Proposal #20: 1620-01-62, WISC 2024125 Marshfield - Abbotsford STH 98 to South Junction CTH N STH 13 Marathon County 1620-01-63, WISC 2024126 Regionwide Concrete Overlays Marathon Co B-37-0184 & B-37-0185 STH 13 Marathon County

This is Addendum No. 01, which provides for the following:

ADDENDUM NO. 1 1620-01-62 December 27, 2023

ID Re) 1 evi	62 ise	0-0)1. Sh	-62 iee	0. 01 123 2023	ALL ITEMS ARE CAT 0010	
									E	\sim	SEEDING MIXTURE		ζ		4.6 3.8 4.0 3.4		7.4 6.0 E.A.A.A.A.A.A.A.A.A.A.A.A.A.A.A.A.A.A.A					2./ 2.3 3.9 3.2			ALL ITEMS A	
1	∝			1					E	L	J	Ĵ) ^m	4	4 4	4	2	14	9	0	4	ν r	ŭ	ö

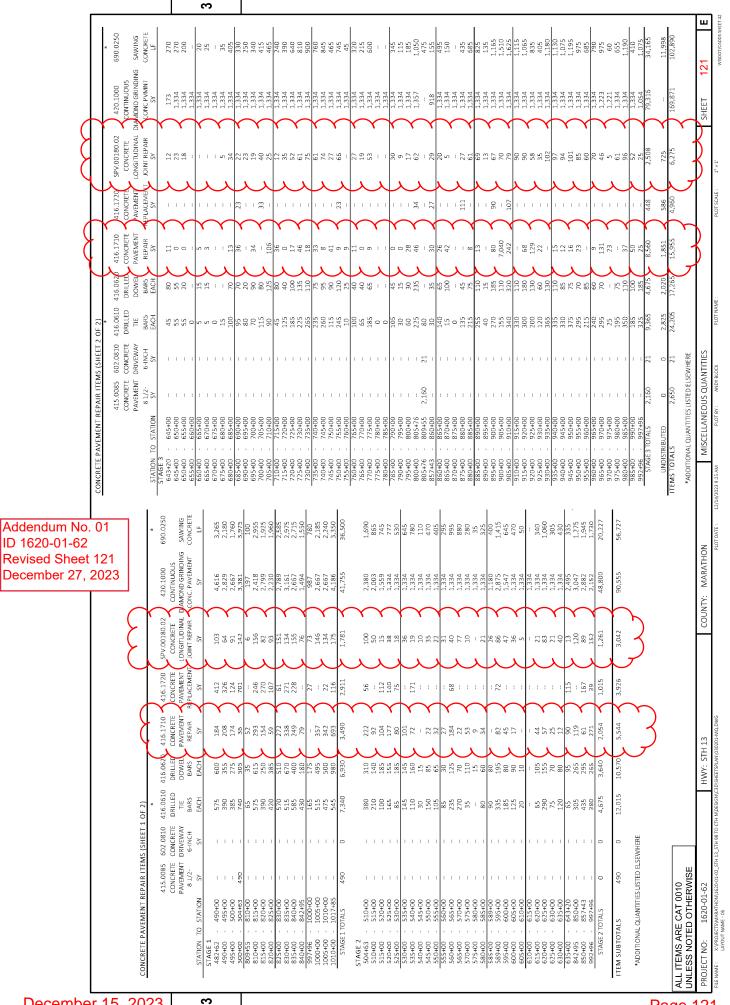
Revised Plan Sheets
Plan Sheet	Plan Sheet Title (brief description of changes to sheet)
9-11 &13	Updated finished typical sections to note that treatment for the existing concrete pavement includes concrete pavement repair, concrete pavement replacement and concrete longitudinal joint repair.
23	Updated the construction detail to define pay limits of concrete longitudinal joint repair vs. concrete pavement repair and concrete pavement replacement
28-48	The legend on the pavement plan details was modified to differentiate between the two bid items listed above.
121	Revised miscellaneous quantity sheet which includes the revised and added bid items.
123	Adjusted the column width on the 'Guardrail Items' table so the type of seed is visible.
